NORTHCREST CENTER DEVELOPMENT PLAN

CONSTITUTION AVE & CANADA DR
COLORADO SPRINGS, COLORADO

Please add "PCD File No. PPR-21-036".

DEVELOPMENT PLAN
-COVER SHEET

SHEET NO: DP.01

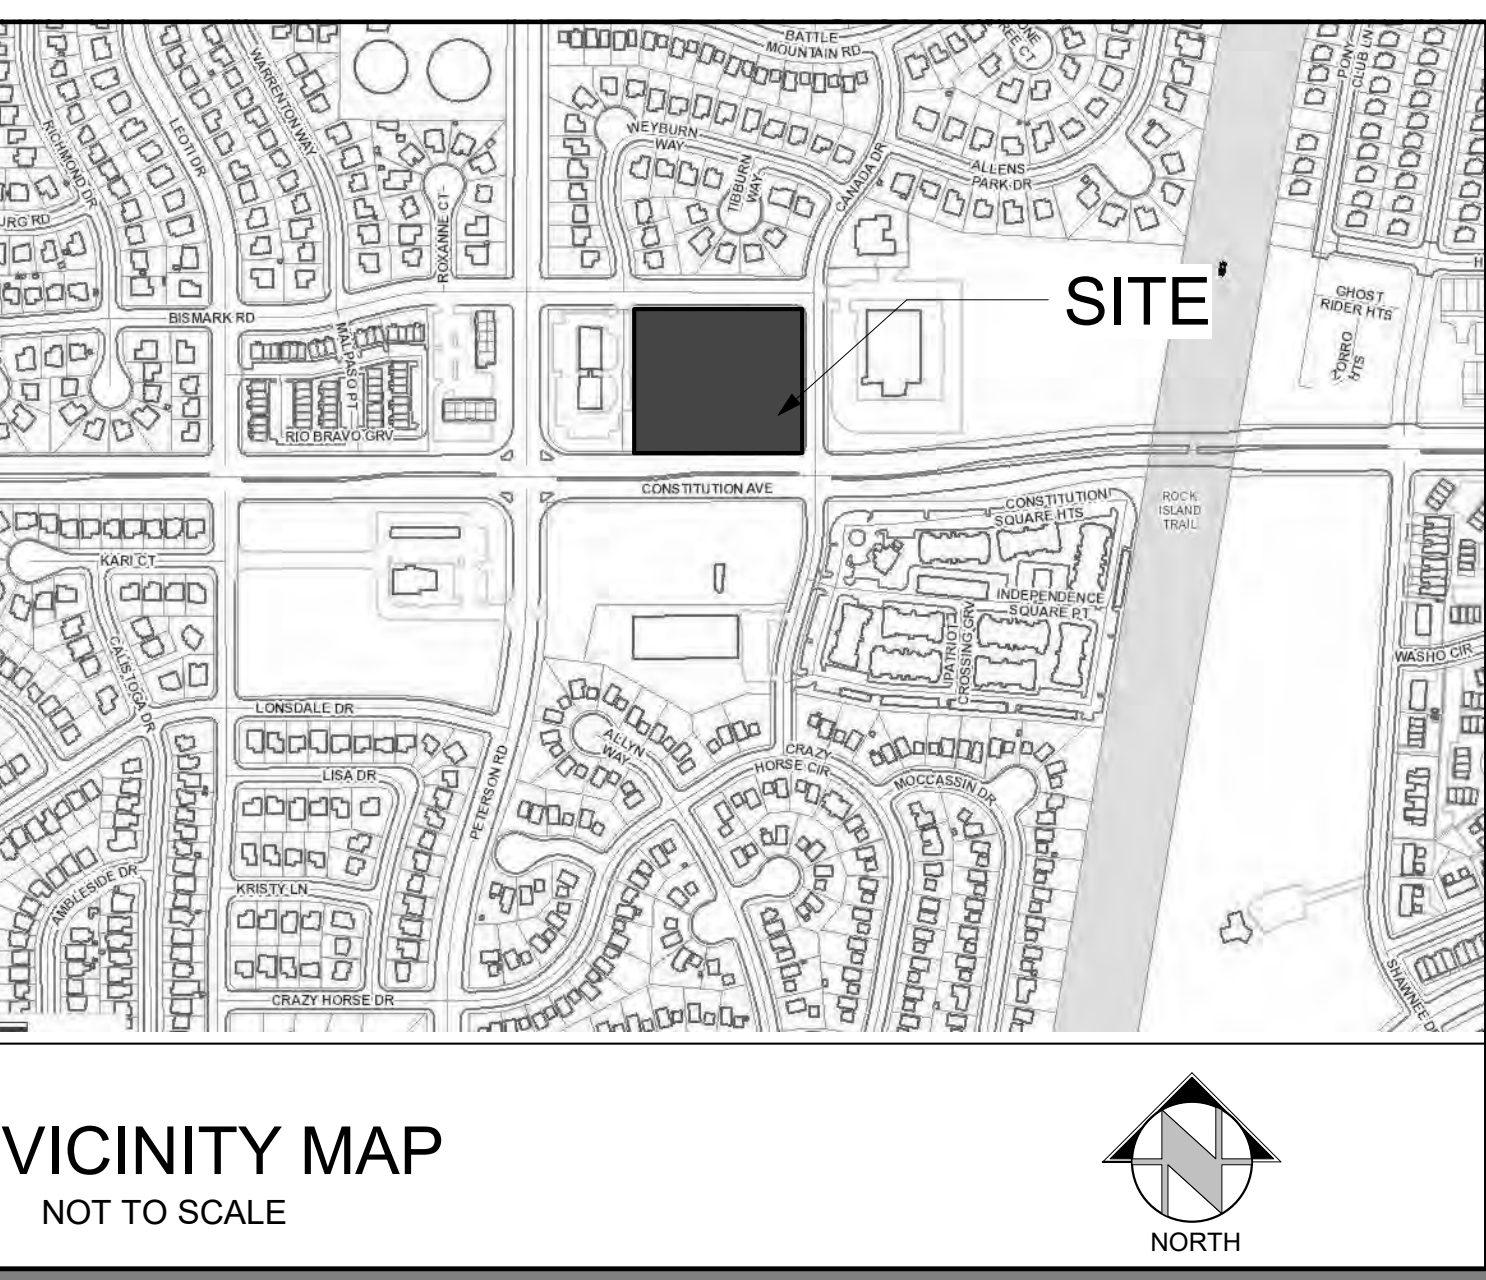
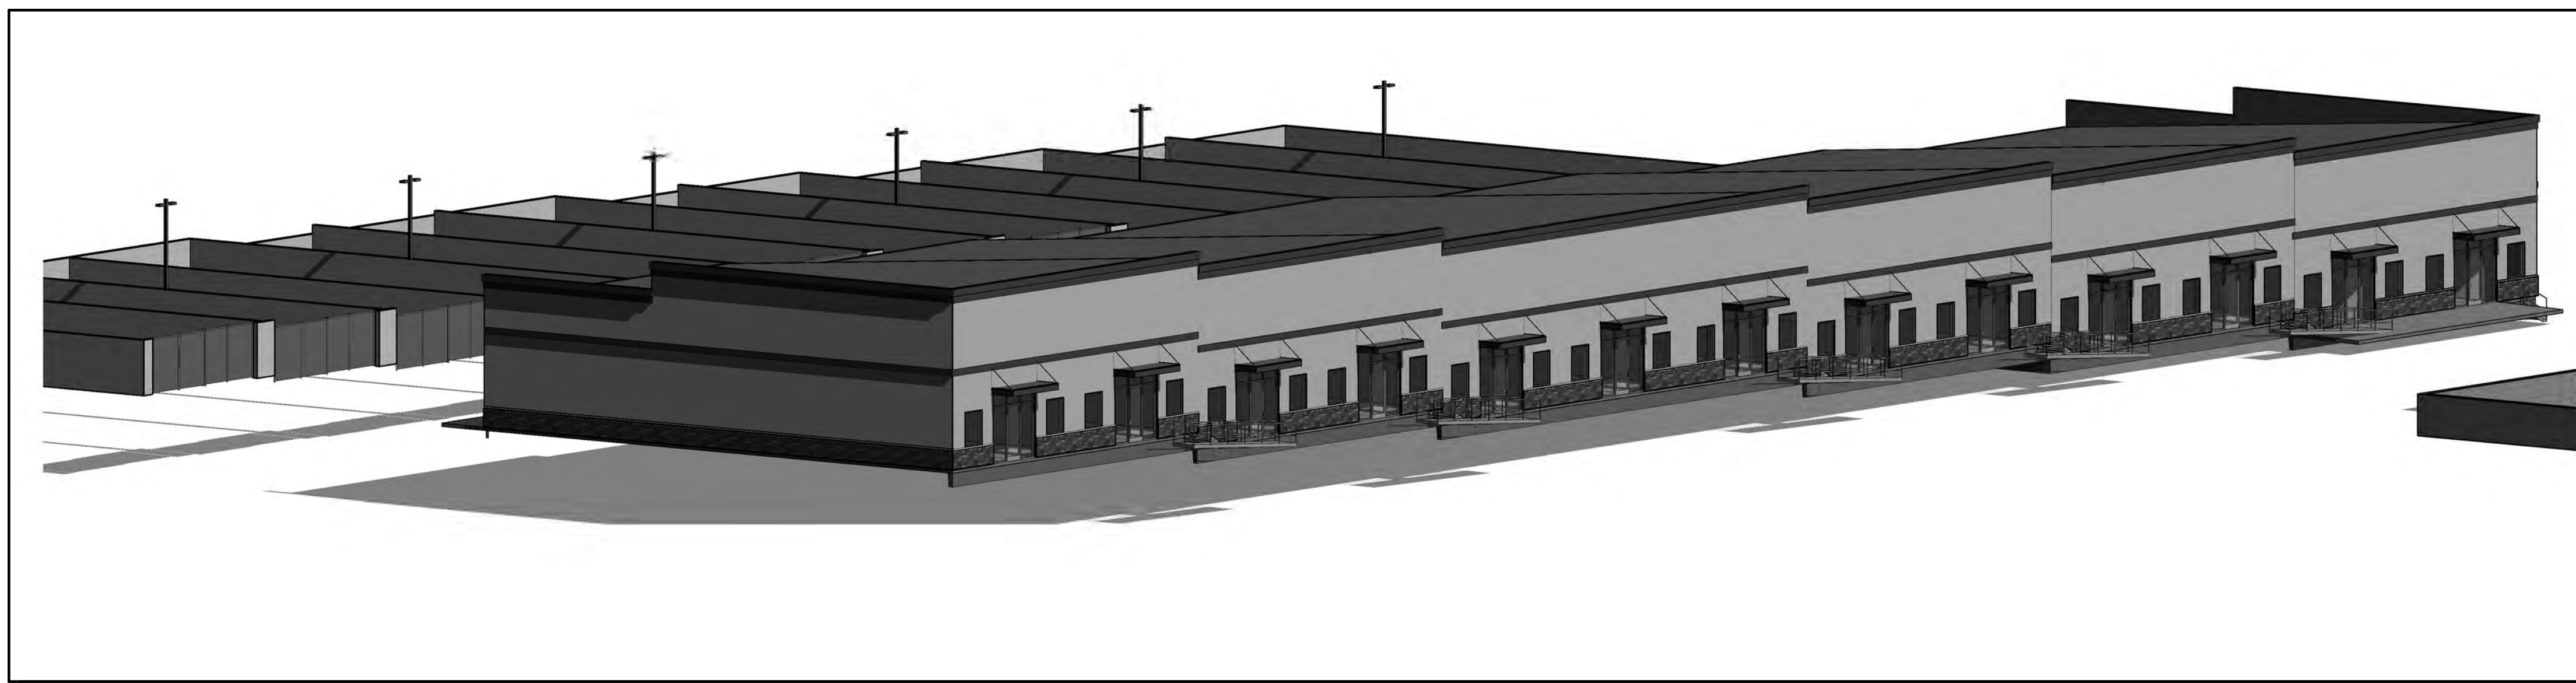
Include requires/provided ADA spaces

Include calculations for impervious surfaces percentage and open space percentage

Show this breakout on floor plans

ARCHENGIN:	Designer
DRAWN:	Author
CHECKED:	Checker
DATE	06.18.21
REVISION	DATE
JOB NO.	180649
SHEET NO.	DP.03

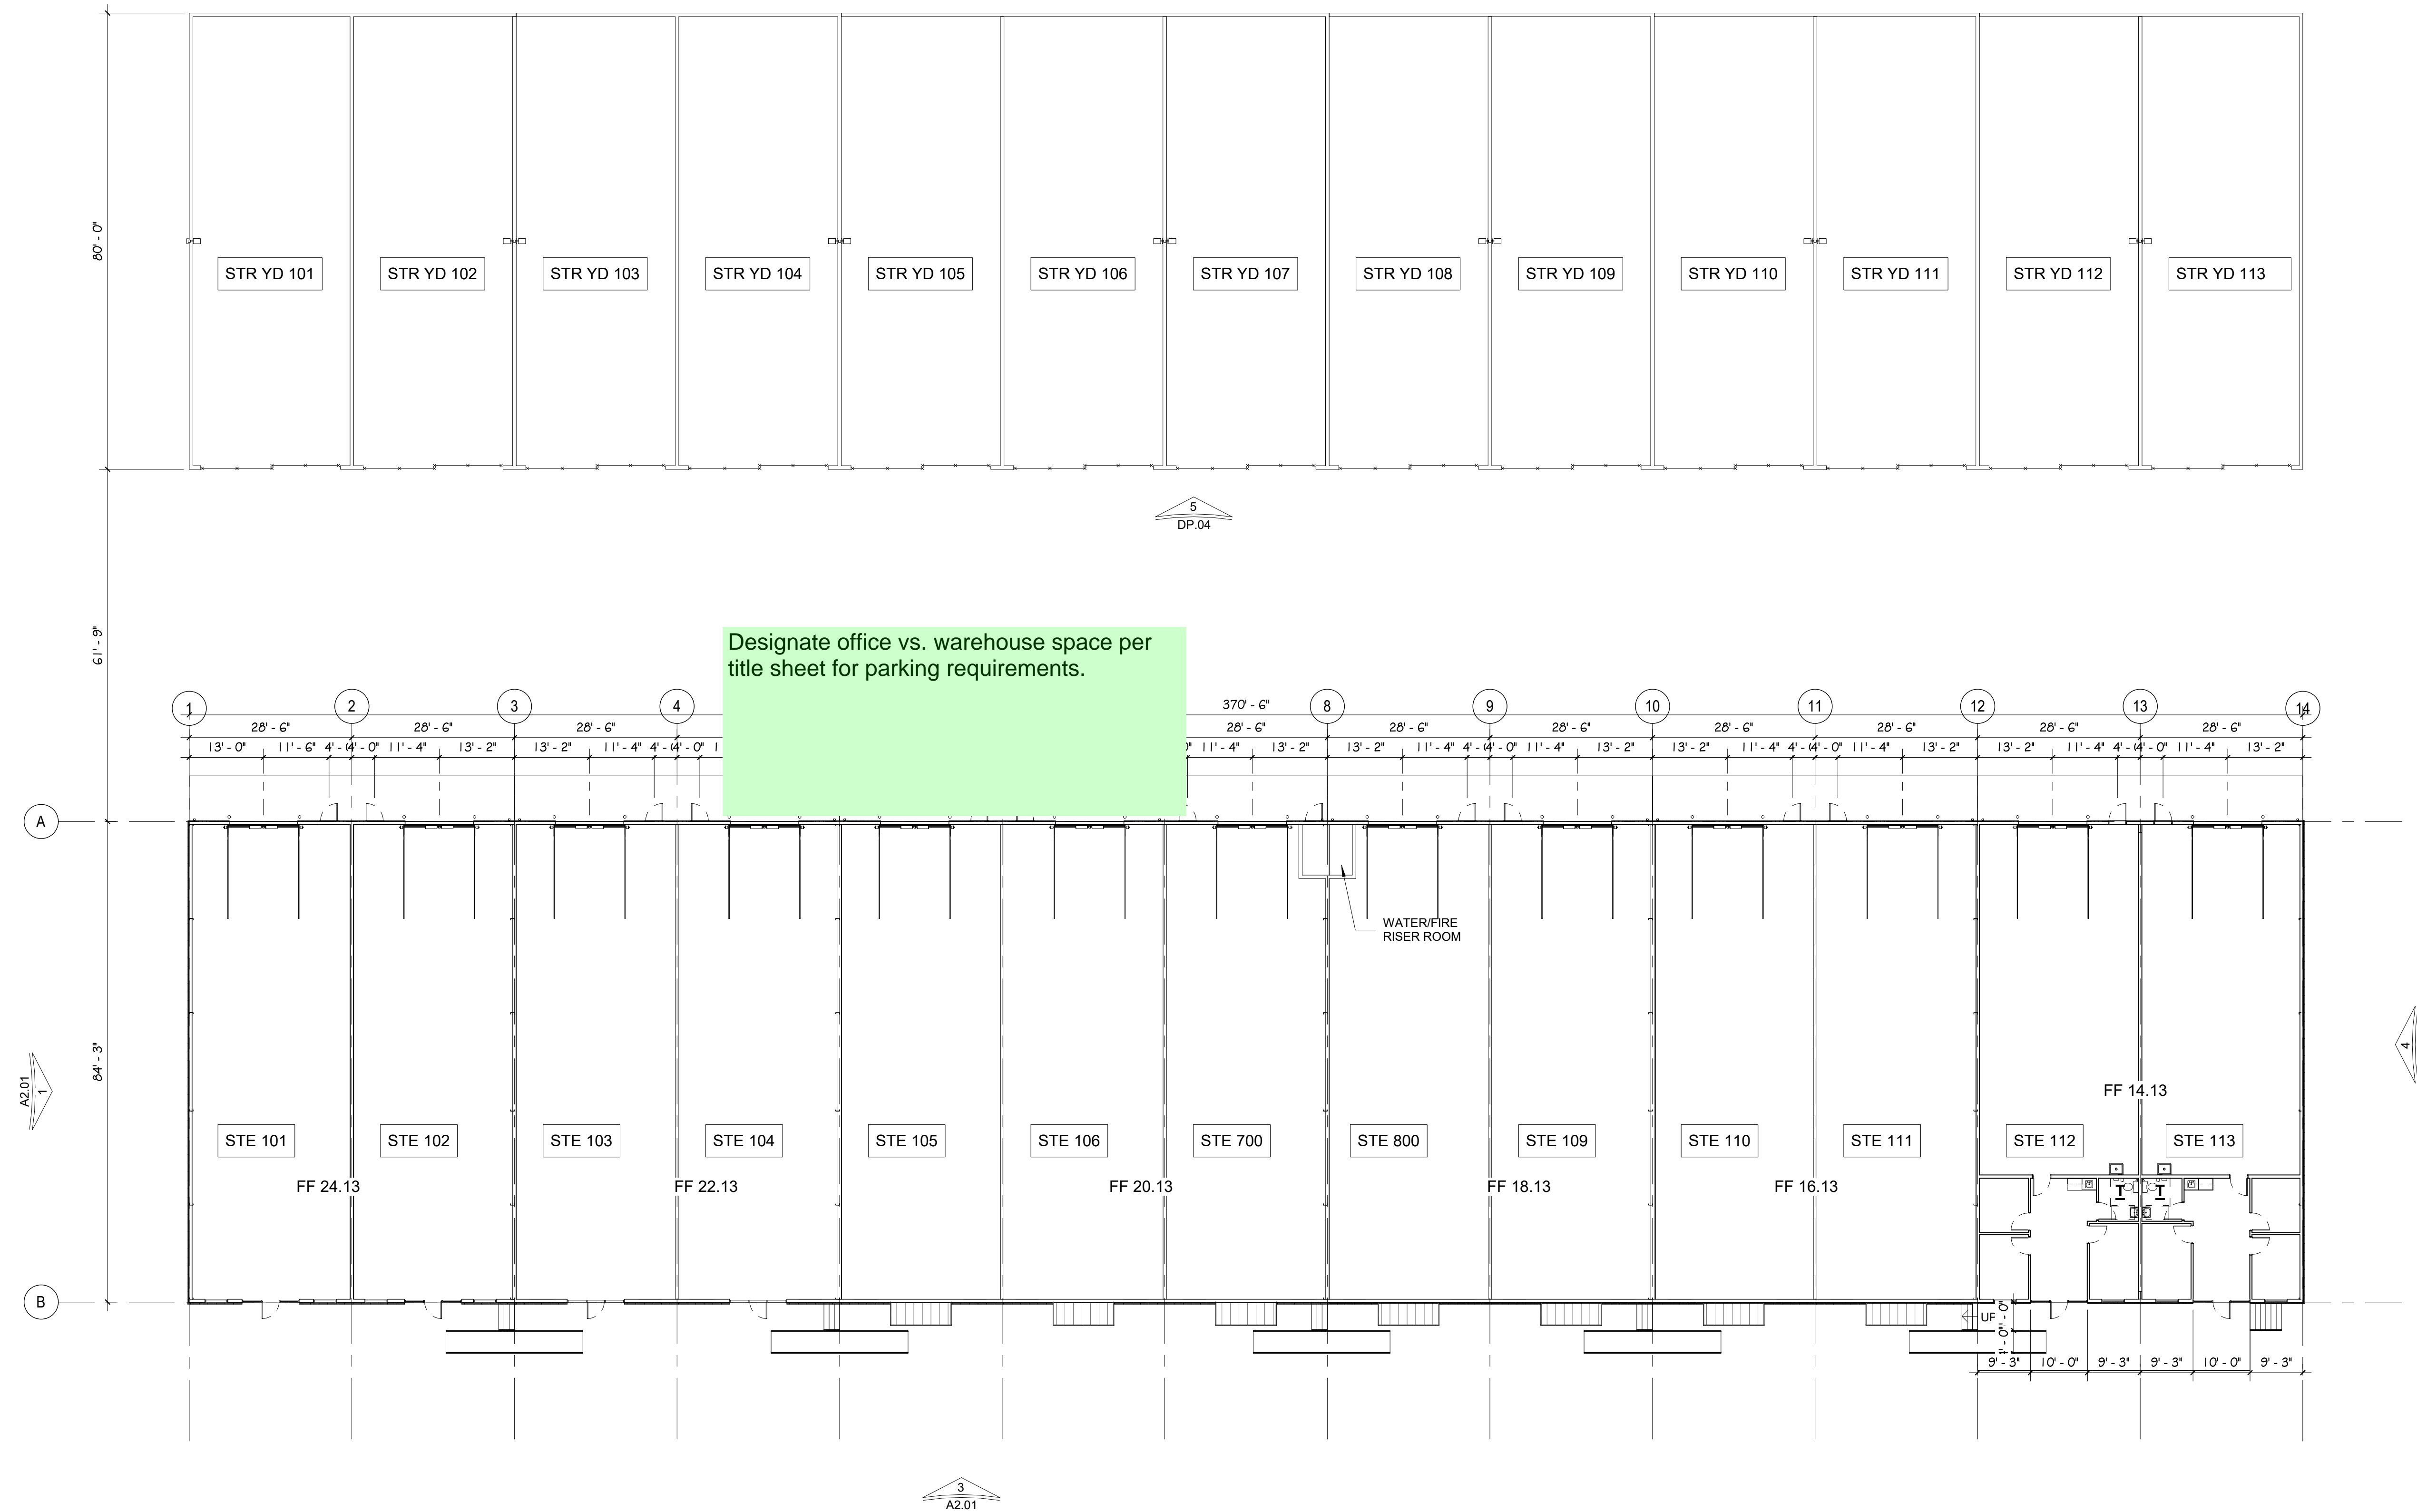
Designate office vs. warehouse space per title sheet for parking requirements.

ENG:	SAM	
DRAWN:	ASP	
CHECKED:	SAM	
DATE:	06/18/2021	
#	REVISION	DATE
JOB NO.:	180649	
SHEET NO.:	DP.05	
	of TBD

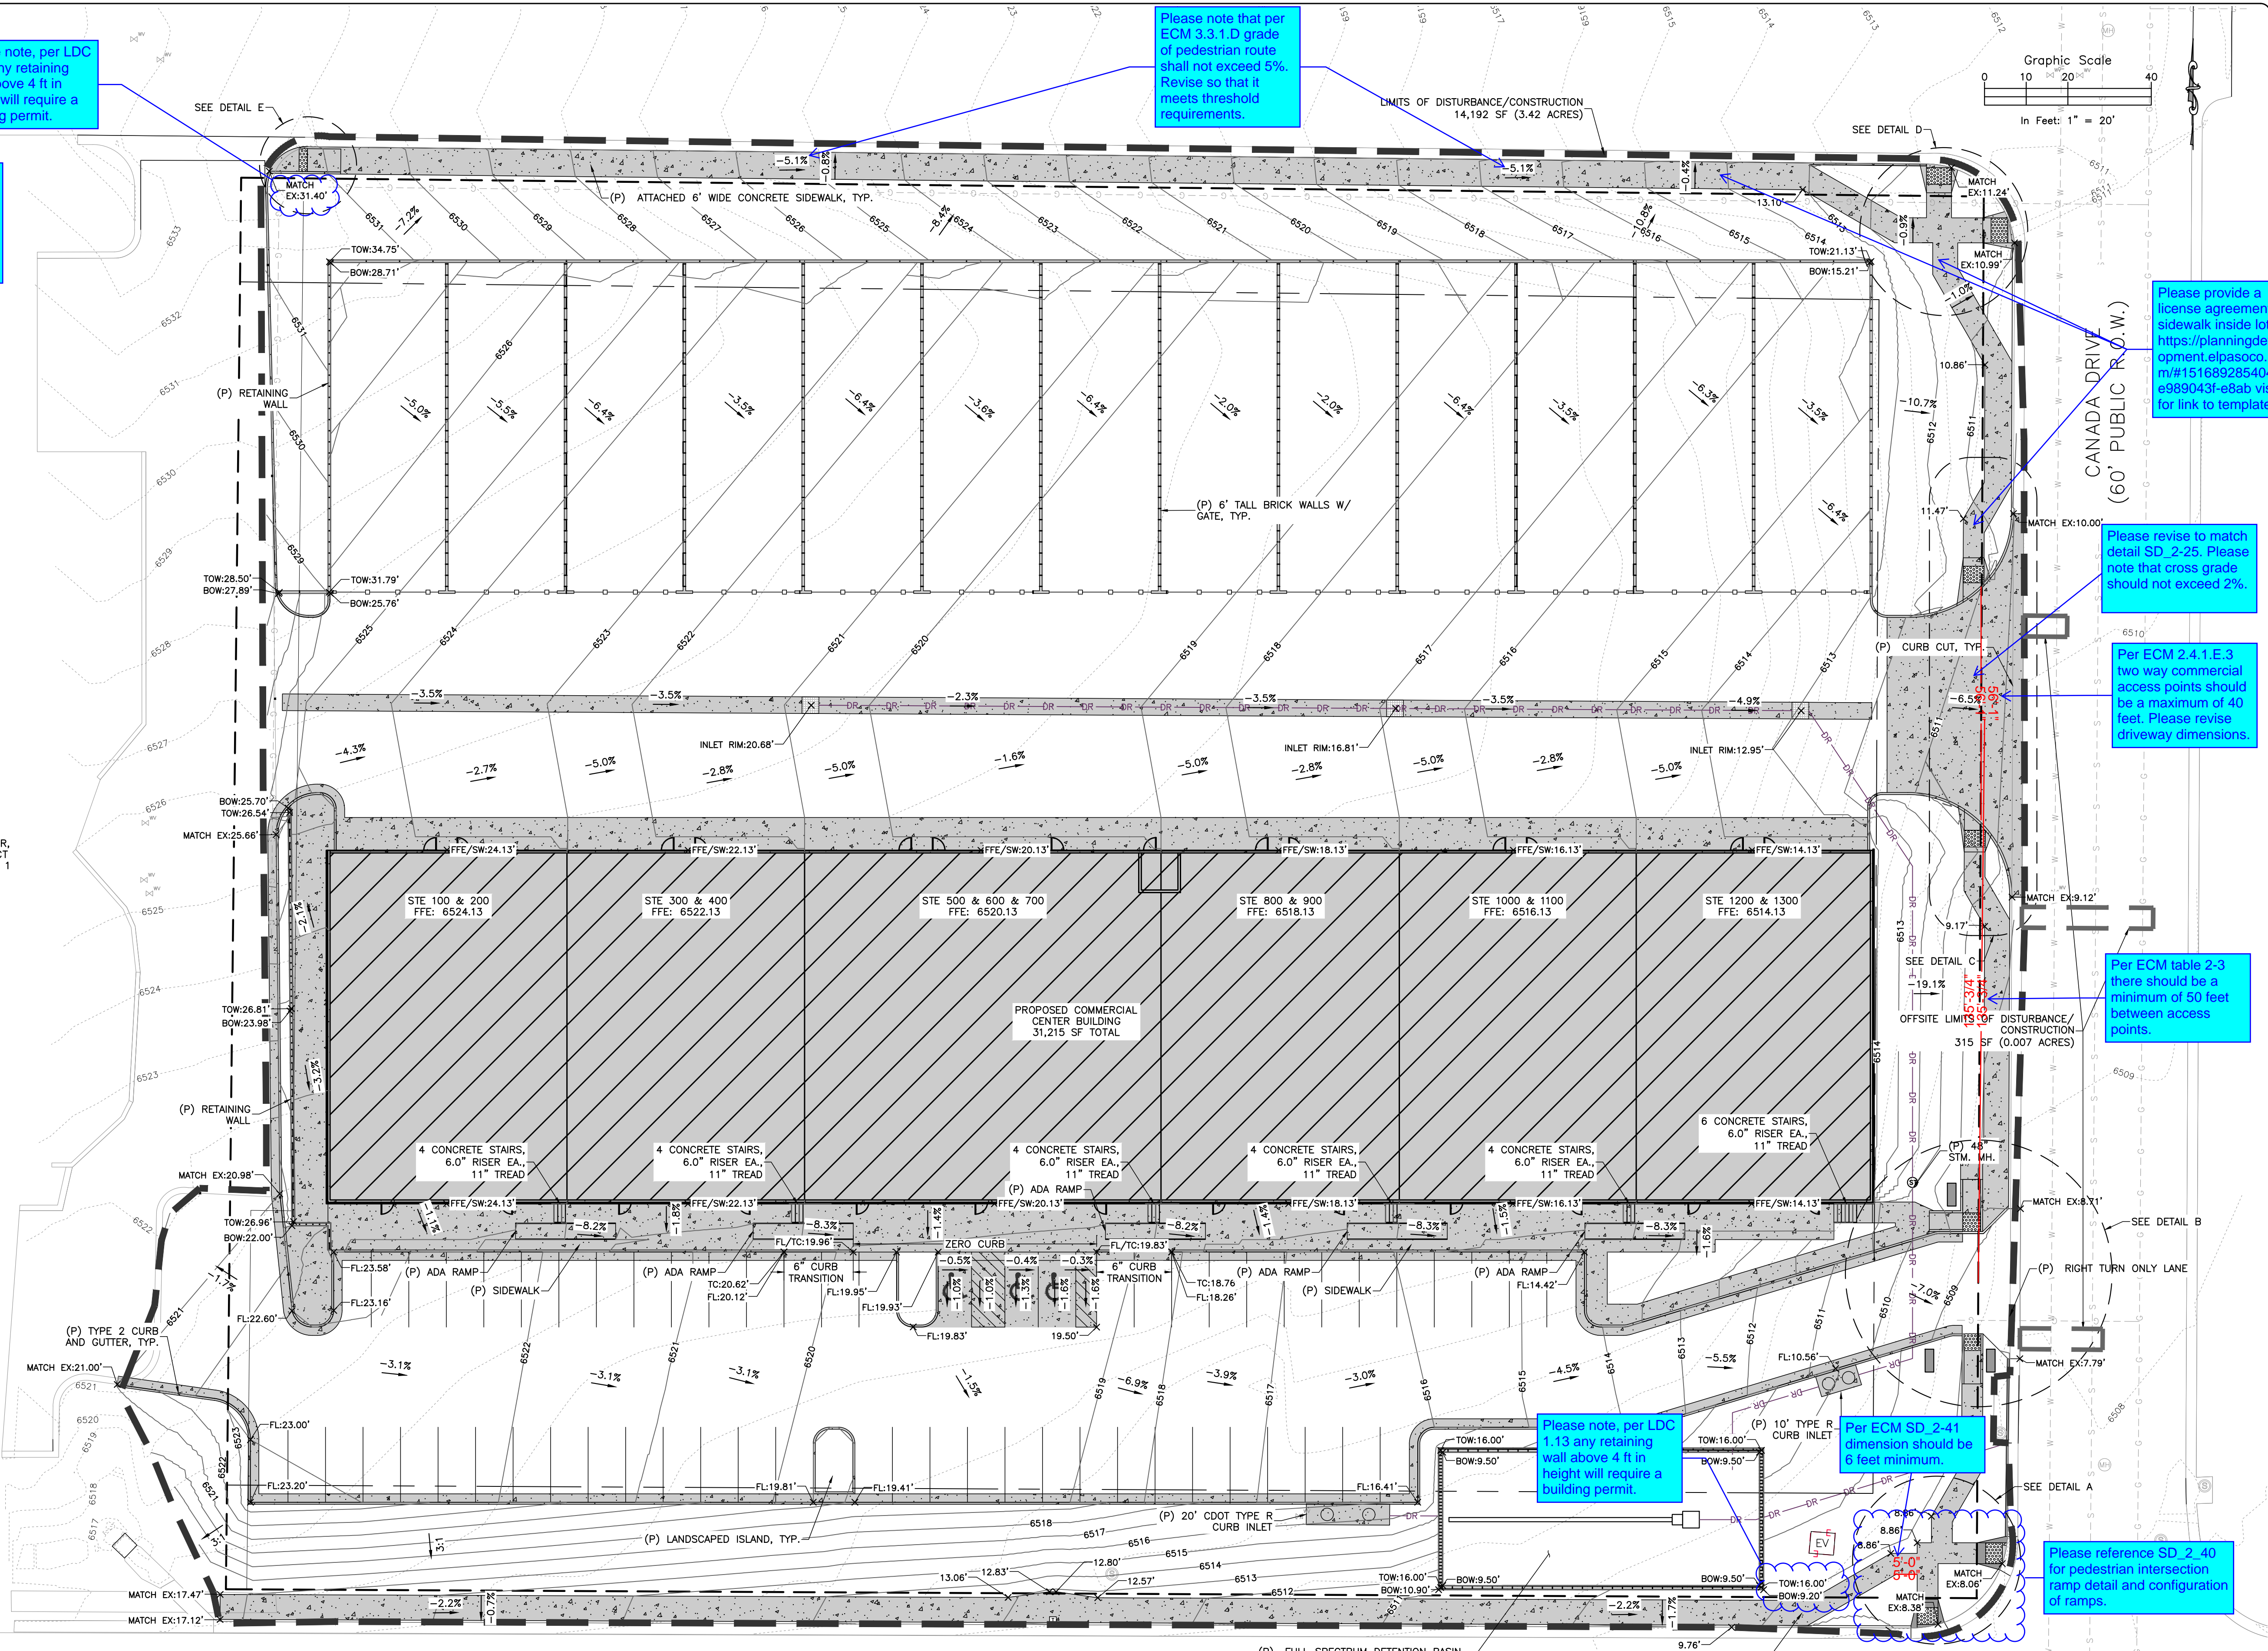
Please note, per LDC 1.13 any retaining wall above 4 ft in height will require a building permit.

Please delete all grading, BMP details, and notes/signature block sheets from the site development plan document. Those sheets should be part of the GEC plan and are going to be approved separately.

Move this sheet to the GEC plan document.

Please note that per ECM 3.3.1.D grade of pedestrian route shall not exceed 5%. Revise so that it meets threshold requirements.

Please provide a license agreement for sidewalk inside lot. <https://planningdevelopment.elpasoco.com/#1516892854045-e989043f-e8ab> visit for link to template.

Please revise to match detail SD_2.25. Please note that cross grade should not exceed 2%.

Per ECM 2.4.1.E.3 two way commercial access points should be a maximum of 40 feet. Please revise driveway dimensions.

Per ECM table 2-3 there should be a minimum of 50 feet between access points.

Please note, per LDC 1.13 any retaining wall above 4 ft in height will require a building permit.

Per ECM SD_2-41 dimension should be 6 feet minimum.

Please reference SD_2_40 for pedestrian intersection ramp detail and configuration of ramps.
